## PLANNING BOARD

Tuesday, June 9, 2026 at 4:30 PM  
City Hall, Room 209, 2nd Floor and  
Zoom

**To:** Chair Zamboni & Members of the Planning Board  
**From:** Sean King  
**Date:** June 3, 2026  
**Re:** 15 & 19 Cedar Street  
**Project ID:** PL-003553-2026  
**CBL:** 026 C015001, 026 C014001  
**Meeting Date:** June 9, 2026

Avesta Housing Corporation has submitted a Major Site Plan application for the construction of a five-story, 26,086 square-foot multi-family residential building at 15 & 19 Cedar Street. The proposed development includes 30 dwelling units, of which 100 percent would be deed-restricted affordable dwelling units, along with community spaces for the residents. The property is located in the RN-4 Residential Neighborhood zone. This application is being referred to the Planning Board for compliance with the City of Portland’s Land Use Code Site Plan Standards, Section 13.6.

Figure A – First floor plan with Staff comments

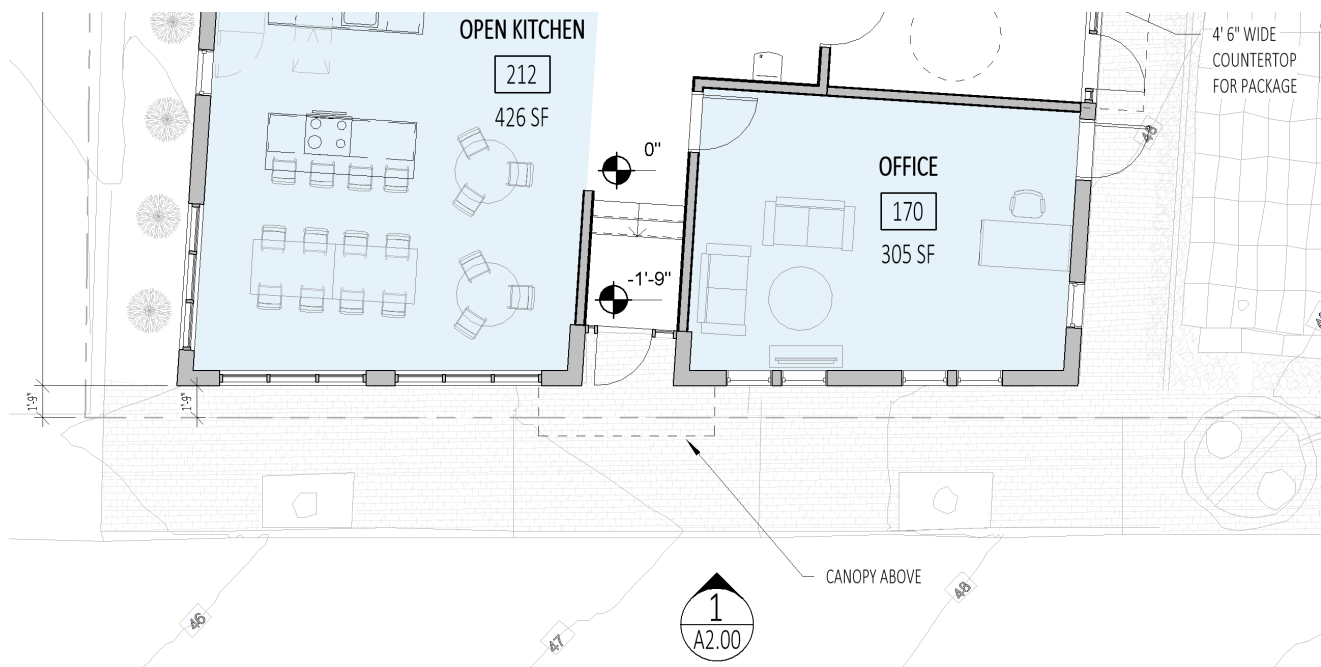
Staff has prepared a design review memo, attachment S4, with comments to provide greater visibility for the recessed entrance at Cedar Street and to specify exterior façade materials onto the architectural elevations.

The front storefront has been repositioned closer to the property line, and the stair has been relocated indoors, significantly reducing the depth of the recessed entry and limiting opportunities for additional sidewall glazing. We felt that the deeper alcoves with limited visibility was creating conditions conducive to loitering, concealed activity, or other undesirable use. The proposed entry design now prioritizes clear visibility and natural surveillance through the full glazed aluminum storefront, allowing direct views between the street and the building.

**DRIVEWAY APRON AT CONSTRAINED SIDEWALK LAYOUT**  
NOT TO SCALE

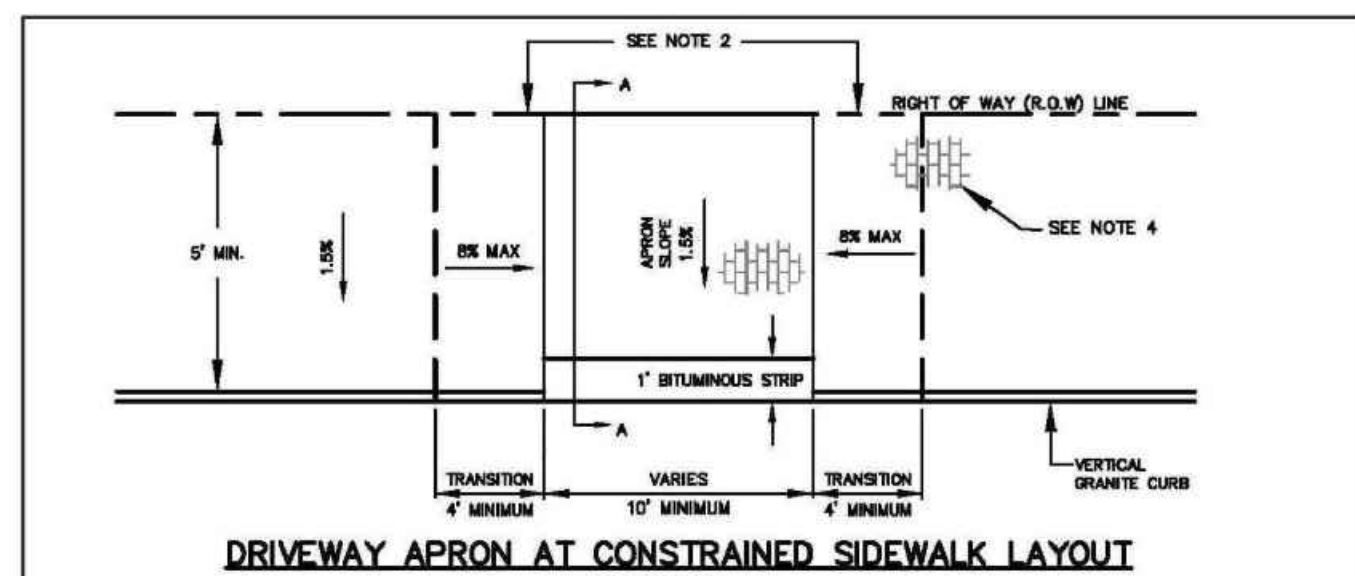
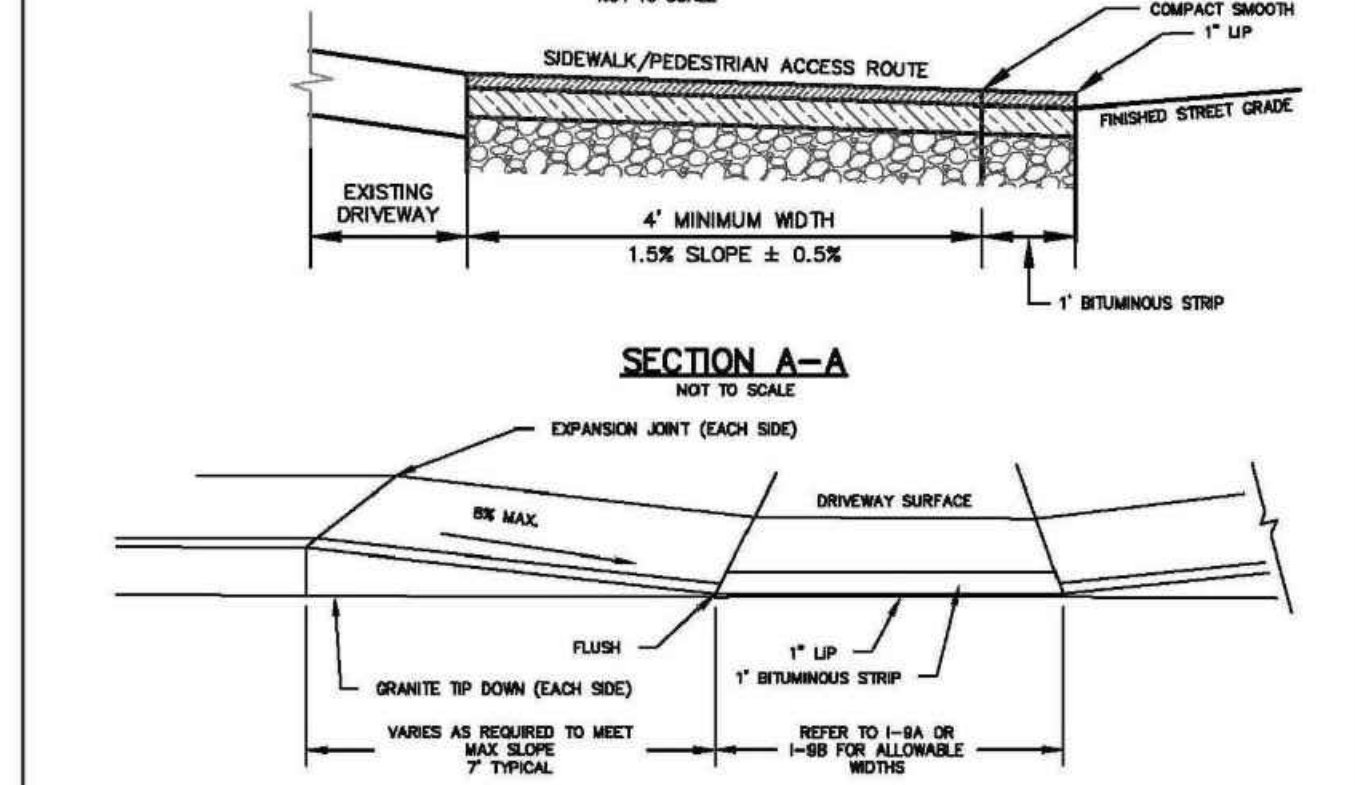
Staff has requested that the applicant provide site details for the driveway apron, brick sidewalk and curbing within the public right-of-way in accordance with the City of Portland’s *Technical Manual*.

**Response: The driveway entrance has been updated to include brick as a final condition, and the plan set has been updated to include detail I-9C of the Technical Manual to bring this into conformance with City Code.**

SHEET  
**9**

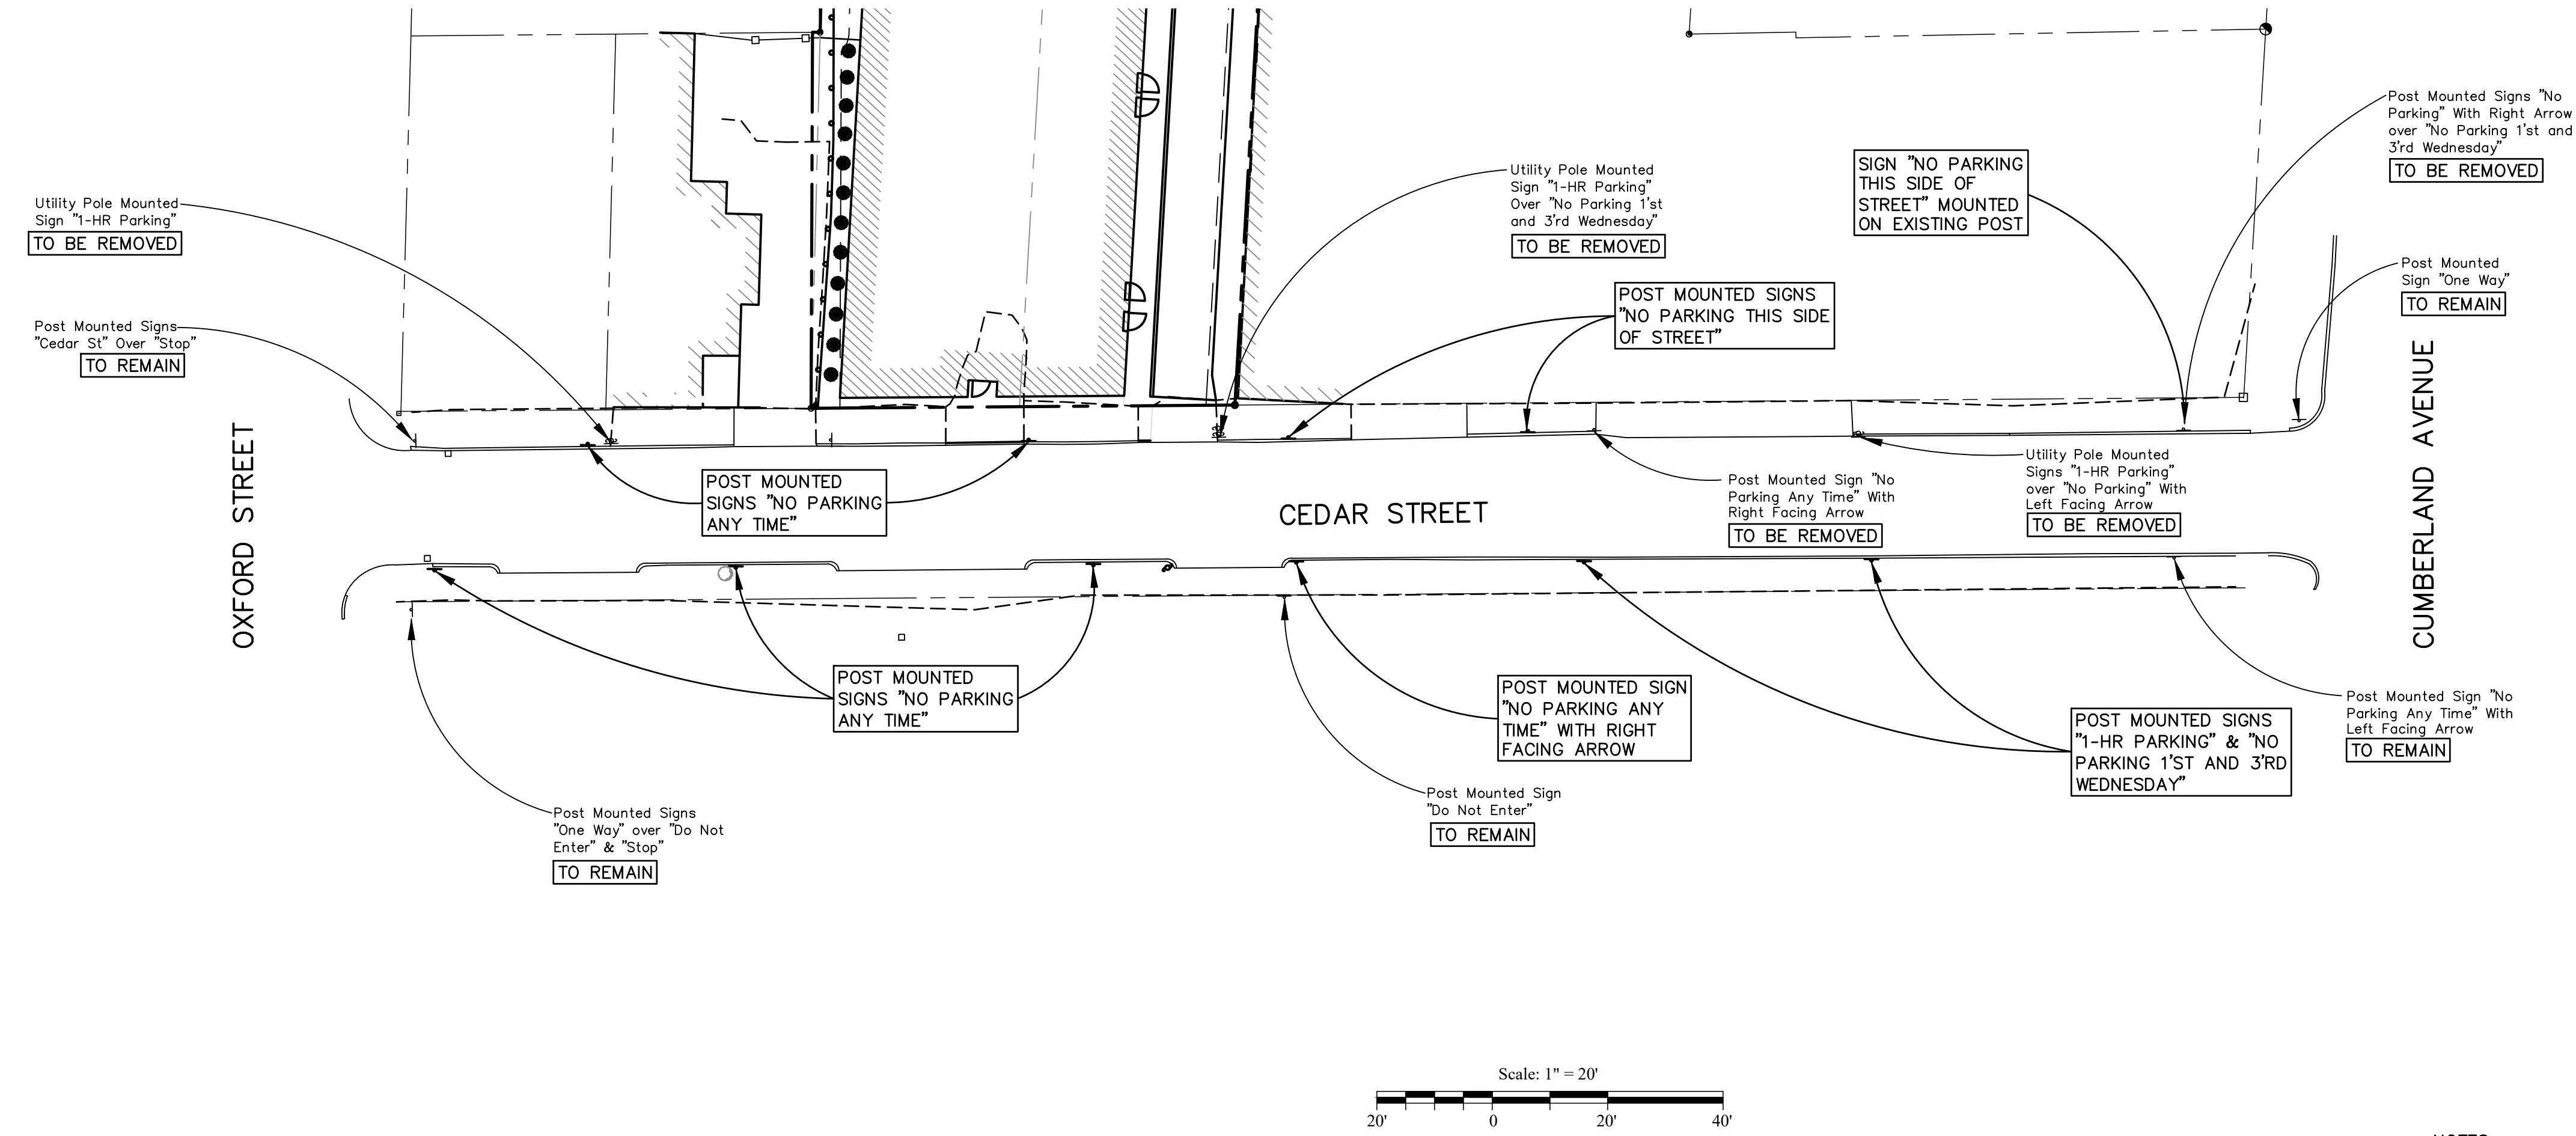
Staff continues to coordinate the reconfiguration of on-street parking spaces that maintains the existing amount in response to the proposed development. See section XI.3.B Public Safety and Fire Prevention for more details.

Staff has requested that the applicant update their site plan to include revised on-street parking signage as detailed under the Parking standard above. The applicant has submitted a proposed parking plan for the reconfiguration of on-street parking along Cedar Street, see Plan 10.

**Response: The project will accommodate this recommendation. We have provided an new plan, Sheet 9, showing more of the existents of Cedar Street with details on the recommended parking signs to be installed as part of the construction of the project. This generally relocates parking to the opposite side of the street, and will remove parking from the frontage of the project to Oxford Street along both sides of the street.**

**Response:** The project proposes to replace and update the parking signage as requested. See updated project plan set, Sheet 9, on the project portal for additional details on sign changes.
